Subject: Vactor Manufacturing 2103 Sewer Cleaner

**Safety Defect and Noncompliance Report Guide for Vehicles**  
**PART 573 Defect and Noncompliance Report<sup>3</sup>**

**Reference Service Bulletin No.: 222**

SUBJECT: SAFETY RECALL - 2103 Debris  
Body Lower Hoist Cyl. Mount

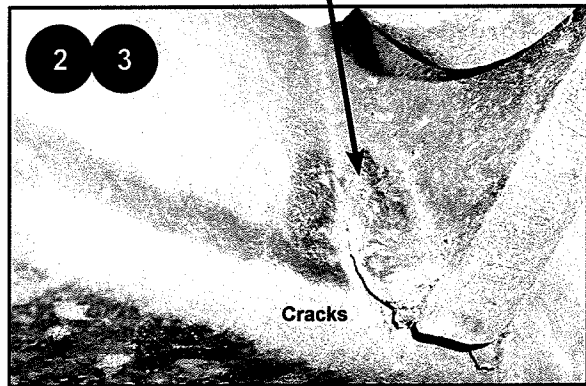
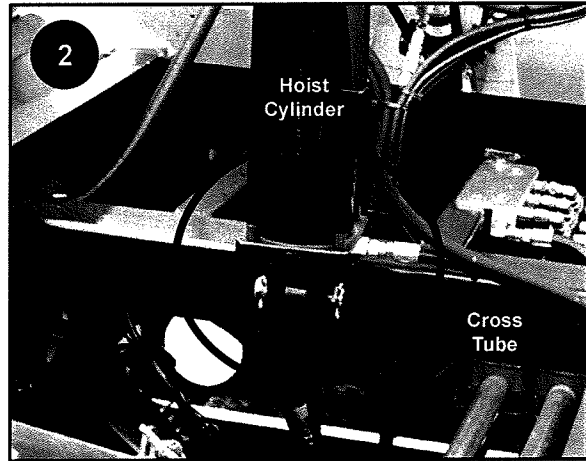
Initial inspection. Clean the area around the lower hoist cylinder mount. Examine the lower hoist cylinder mount, supporting tube and structure for cracks or deformation.

**If you see any cracks or deformation during the inspection DO NOT OPERATE OR USE THE MACHINE.**

**Call your Vactor Dealer Service Department immediately and reference Service Bulletin 222.**

If no cracks or deformation are present during the initial inspection, the unit may remain in service as long as a pre-operation daily inspection of the areas is performed. **Contact your dealer and schedule for the repair.**

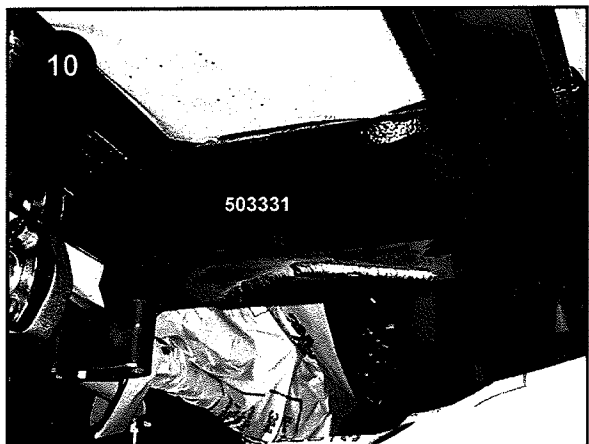
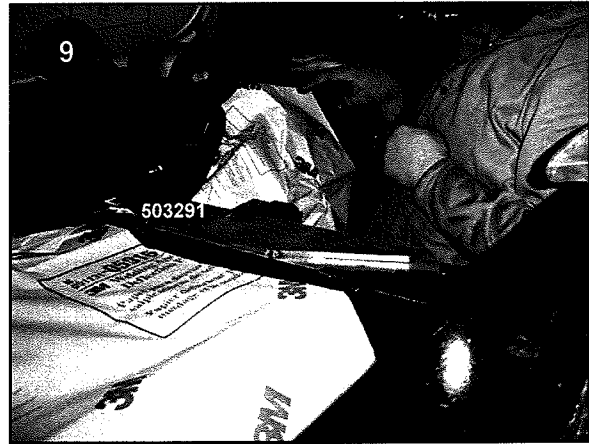
From the kit 503352 locate 503291 around the lower hoist cylinder mount. It may be necessary to grind some of the existing weld on the hoist cylinder mount so that 503291 fits up flush to the cross tube surface. Repeat for 503331. Refer to the drawing 503352 for additional details.

Weld up both plates as described on the drawing 503352 to the required specifications.

**VACTOR MANUFACTURING INC. STRATOR, IL**  
 CYLINDER SUPPORT INSTALL, 2103 SUBFRAME

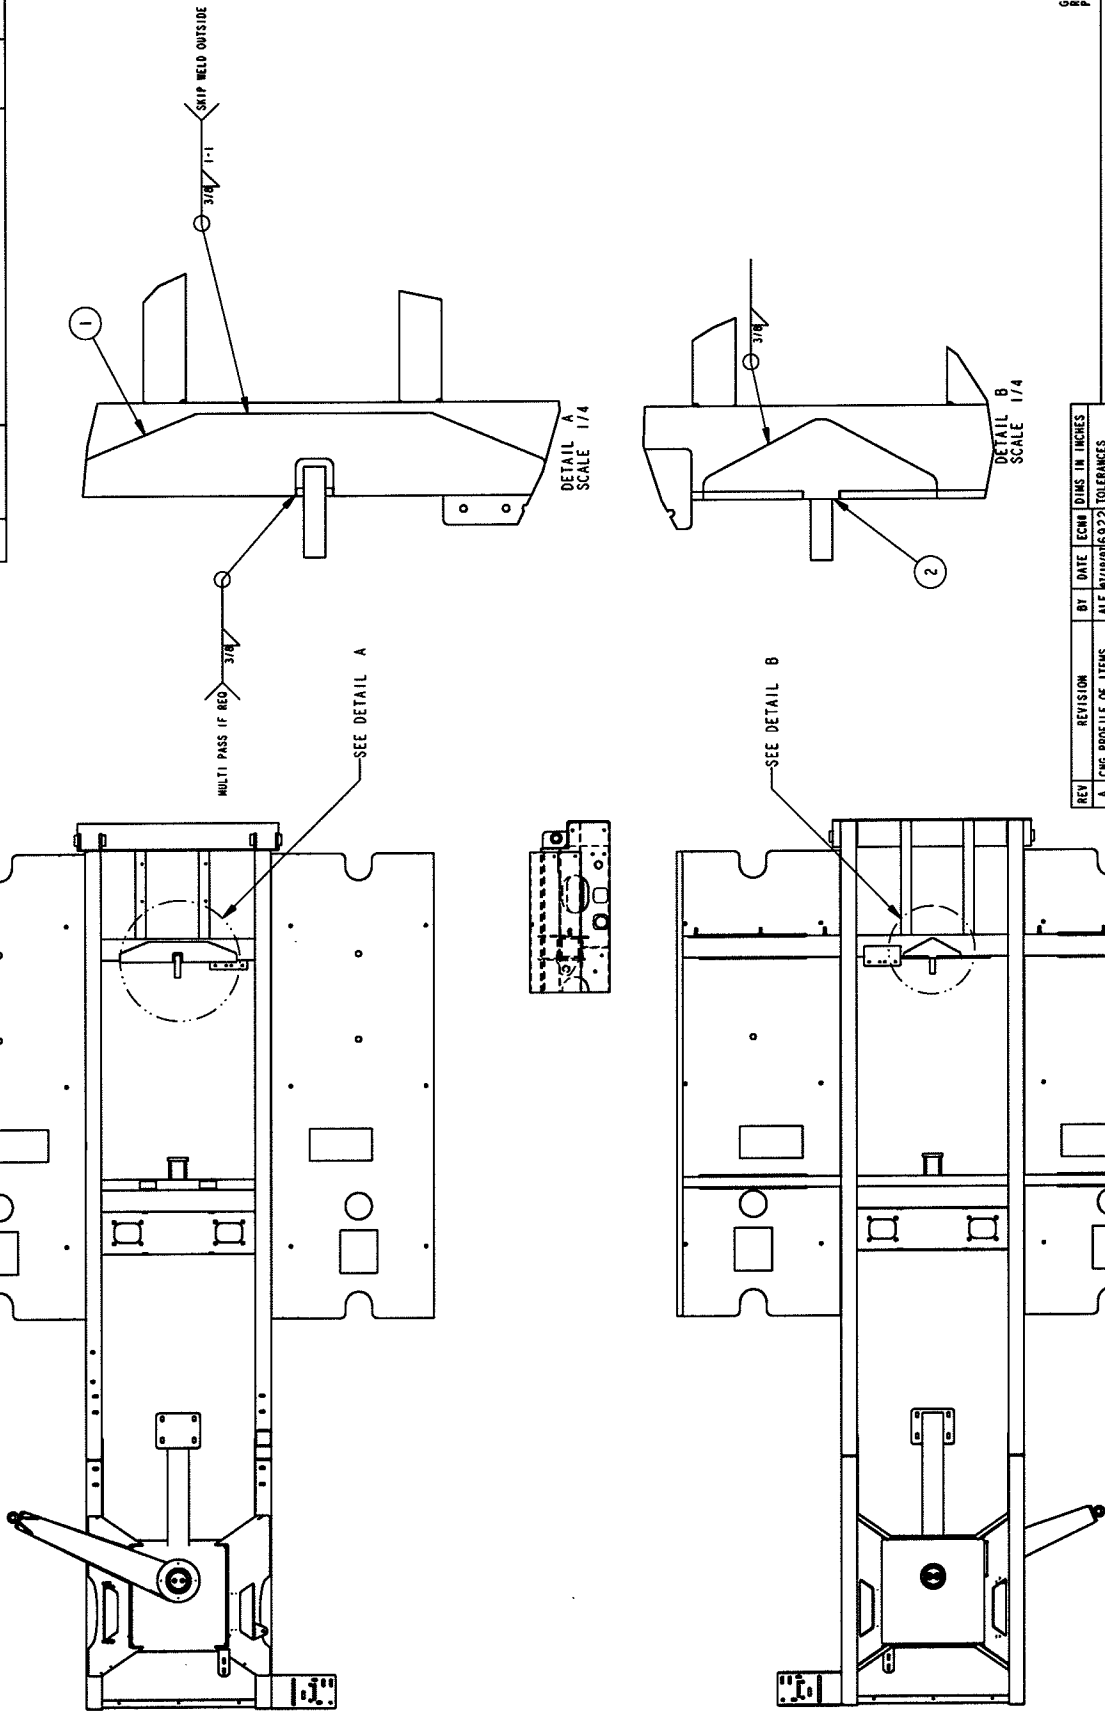
Some cracking has been found at the lower debris body hoist cylinder mount on 2103's. A reinforcement has been developed for field service. See attached drawing 503352.
